HDC-2023-00032

Address: 614 N. Law Street

Proposal: Legalize vinyl porch railings (violation correction)

Historical Architectural Review Board COA Final Review Sheet

Detail of vinyl railing, 2023. (HARB files)

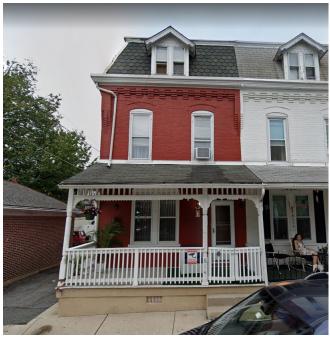
On May 12, 2023, staff issued a notice of violation for the installation of vinyl porch railings where non-original wood railings previously existed. This application seeks to legalize the vinyl railings. Staff notes that the corner porch post has also been recently replaced without a Certificate of Appropriateness.

The previous railings consisted of a simple wood picket system and appeared to have replaced historic turned balusters, which are visible in the survey completed when the district was designated. The vinyl railings do not comply with Guideline 3.7.8, which notes that "vinyl railings and trim are not appropriate alternate materials for wood elements." Staff suggests that painted turned wood balusters be installed in place of the vinyl railings, with some flexibility in design since the historic balusters were replaced several decades ago.

Mr. Huber noted that a portion of a bracket was also missing at the top of the replaced column. He suggested that it be restored as part of the scope to legalize the work, since it appears to have been broken during the replacement of the column. The HARB discussed returning the railings to wood to match the previous railings and commented that the porch column should match the historic column. Mr. Disla agreed to return the porch to its previous appearance and amended the scope of work.

Mr. Encelewski moved to approve the amended application presented on 6/5/2023 to replace the porch railings and column with appropriate wood railings and a wood column, with the staff to review details, pursuant to Chapter 3, Section 3.7 Porches & Steps. Mr. Lichtenwalner seconded the motion, which carried with unanimous support.
